**CONWAY**  
HISTORIC DISTRICT COMMISSION  
JUNE

# A CONNELL RESIDENCE REMODEL - 2136 WEEMS STREET

## OLD CONWAY DESIGN OVERLY DISTRICT CERTIFICATE OF APPROPRIATENESS CONNELL RESIDENCE REMODEL 2136 WEEMS STREET

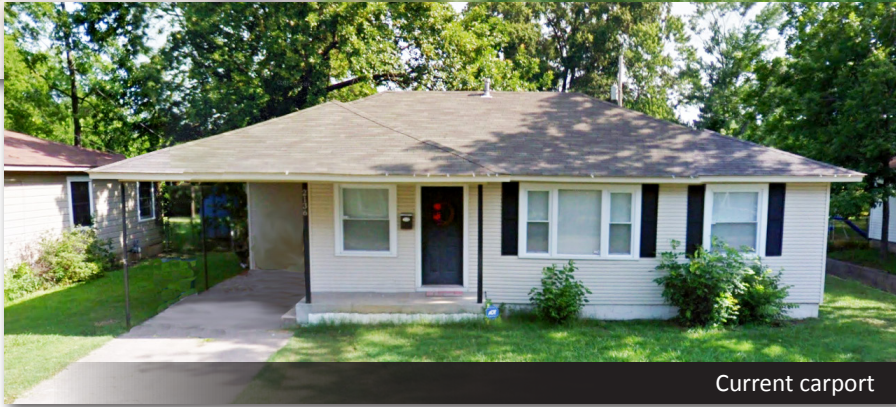
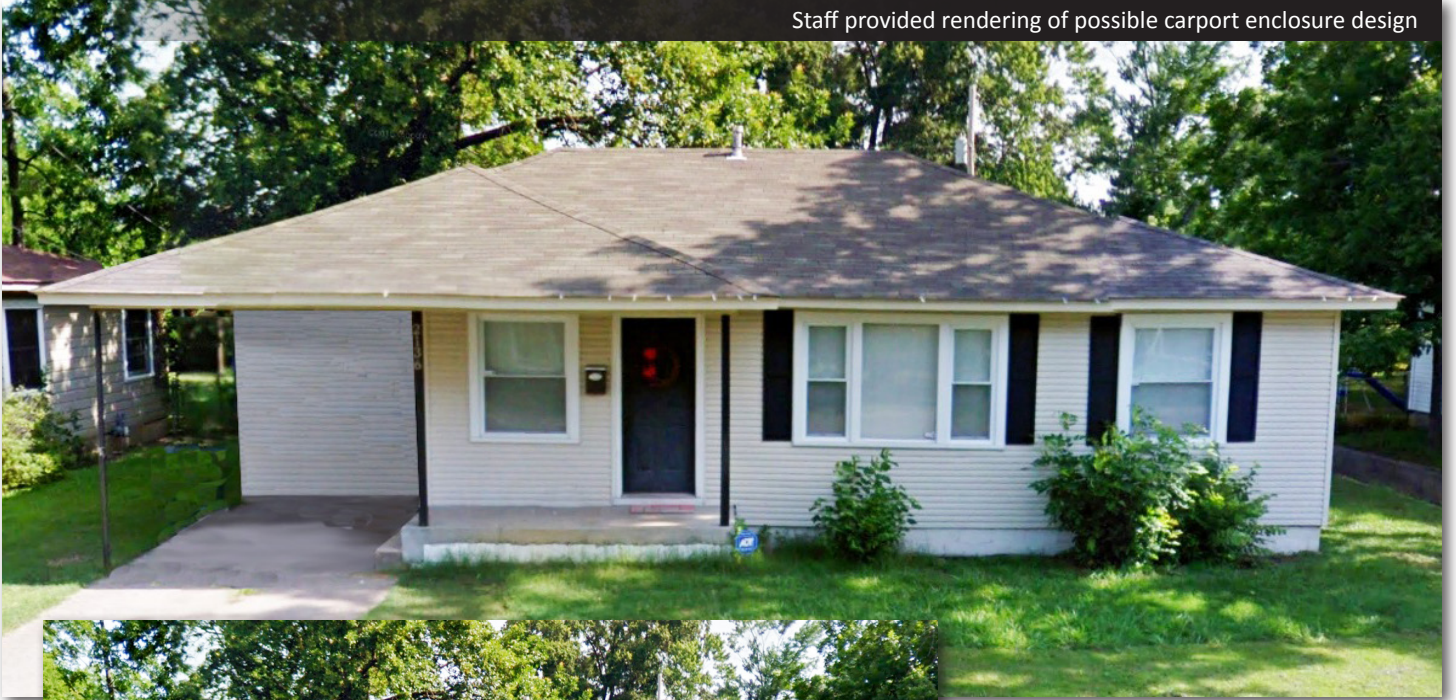
**Complexity of form.** The level of detailing and breaks in wall planes of a structure. The carport enclosure will be set back approximately 9 feet from the front facade of the house. This will create a more recessed appearance to the enclosure. This recess should retain some of the original carport appearance to the residence.

**Architectural Details, Siding, and Bricks.** Eaves, brackets, dentils, cornices, molding, columns, trim, etc. The residence's siding has been replaced with hardie-board. The carport enclosure and garage will also be clad with hardie-board. As a ranch style house there is little detailing. The enclosure, screen porch, and garage will also have minimal detailing and will blend with the residence.

**Decks/Plaza Space.** A 12' x 16' screen porch is proposed. This would be a typical porch roof with wooden post and screening set on a concrete slab.

The proposed carport enclosure should blend appropriately with the existing residence. The entire house's siding was recently upgraded with hardie-board. The carport enclosure and garage will also be clad with hardie-board. The enclosure will be recessed from the front facade lessening it's visual impact. The screen porch and garage will be typical construction and largely hidden from public view. Porch railing is also proposed.

1. The carport enclosure, screen porch, and garage shall be constructed as shown in submitted plans.
2. Hardie-board or similar cement siding shall be used to match existing siding.
3. Decorative porch railing may be added.
4. A gravel driveway shall be allowed?
